Draft Evaluation of the Cape Wind Energy Project Proposed Site and Alternatives With the Offshore Wind Energy Project (OWEP) Model; A Microsoft Excel Cash Flow Spreadsheet

By: Robert S.D. Mense
Economics Division
Minerals Management Service
Herndon, VA

May 25, 2007

Response to Peer Review Comments
Submitted for the Report Titled: "Evaluation of the Cape Wind Energy Project Proposed Site and Alternatives With the Offshore Wind Energy Project (OWEP) Model; A Microsoft Excel Cash Flow Spreadsheet"
September 26, 2007

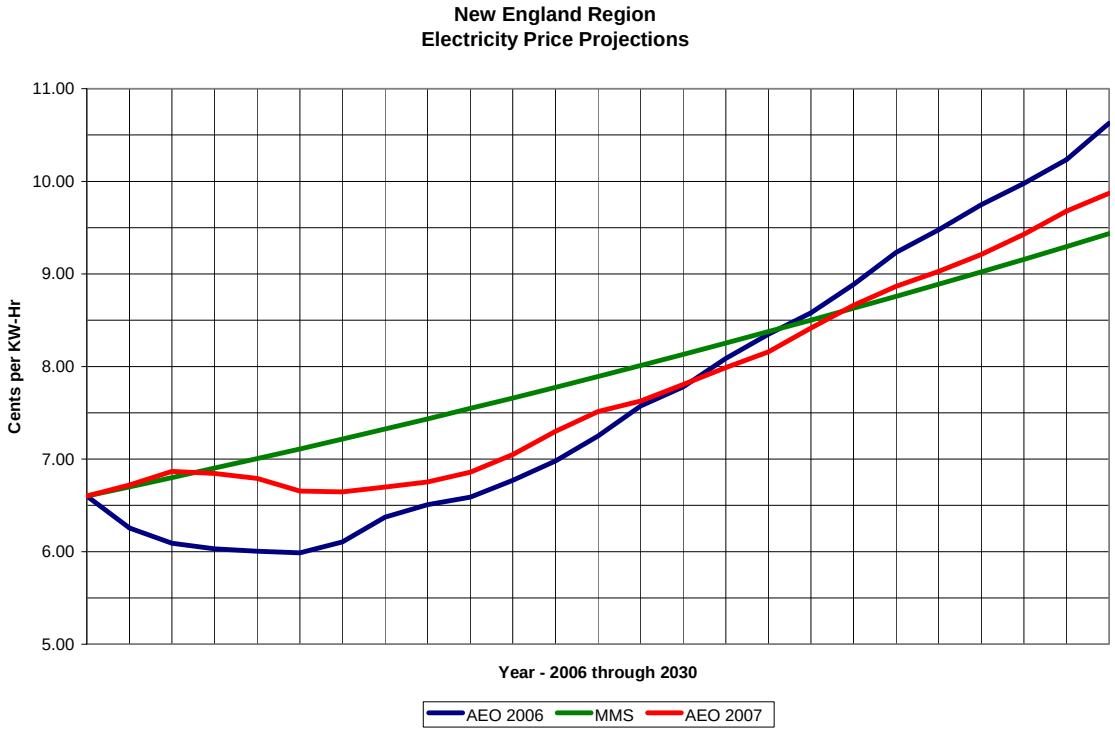
7. Electricity price and operating cost escalation rates were questioned. One comment stated that given the analysis's inflation assumption of 2.5% per year, the assumption that electricity prices will increase only 1.5% nominally (i.e., decline in real terms) is difficult to accept. A correlation or link between the EIA AEO oil and gas price forecast or NYMEX natural gas prices was suggested by more than one peer reviewer.

Response:
Before conducting the economic evaluations for the Cape Wind Energy Project draft EIS, locational marginal price data for the southeast Massachusetts load zone, as reported by the ISO for the real-time market, was downloaded from the internet site at http://www.iso-ne.com/markets/hstdata/znl_info/monthly/index.html. A starting electricity price of $65.97 per MWhr, or 6.60¢ per KWhr, was determined for the preliminary evaluation of the proposed site, as referred to in item 6 above, by calculating the average over the 2 year period from February 2005 through January 2007. (An updated calculation yielded an average price of $67.81/MWhr over the 2 year period from June 2005 through May 2007. For May 2007, the average price was $65.51/MWhr.) The average electricity price of 6.60¢ per KWhr was used as the starting price for each projection in the chart below. Price trends were projected by applying price escalation factors to the starting price.

The MMS projection was an approximation of the price projection determined from information published in the Annual Energy Outlook (AEO) for 2006, Tables 8 and 19, posted on the internet at http://www.eia.doe.gov/oiaf/archive/aeo06/aeoref_tab.html. As the chart shows, in addition to the MMS and AEO for 2006 projections, a projection is

also displayed from information in the AEO for 2007 posted on the internet at http://www.eia.doe.gov/oiaf/aeo/aeoref_tab.html. The MMS projection was based on the assumption that the product of the inflation rate and price growth would be 1.5% annually, and was made before the AEO for 2007 was published in February of 2007. The AEO price paths were projected by adjusting the starting price of 6.60¢ per KWhr with an annual price escalation factor calculated as the product of: a) growth – utilizing the "Prices by Service Category 9/Generation" forecast of electricity prices reported in Table 8, and b) inflation – utilizing the GDP Chain-type Price Index found in Table 19, from the respective AEO issues. The growth rate adjusts electricity prices to match the annual price changes in Table 8 of the AEO national electricity price forecasts. The inflation rate converts the electricity prices to nominal dollars. Substitution of the AEO for 2006 or 2007 national price projections for the MMS price projection would give slightly different COE results, but the difference is approximately five percent, too small to have had a significant effect on the magnitude of other economic performance measures or the ranking of the sites.
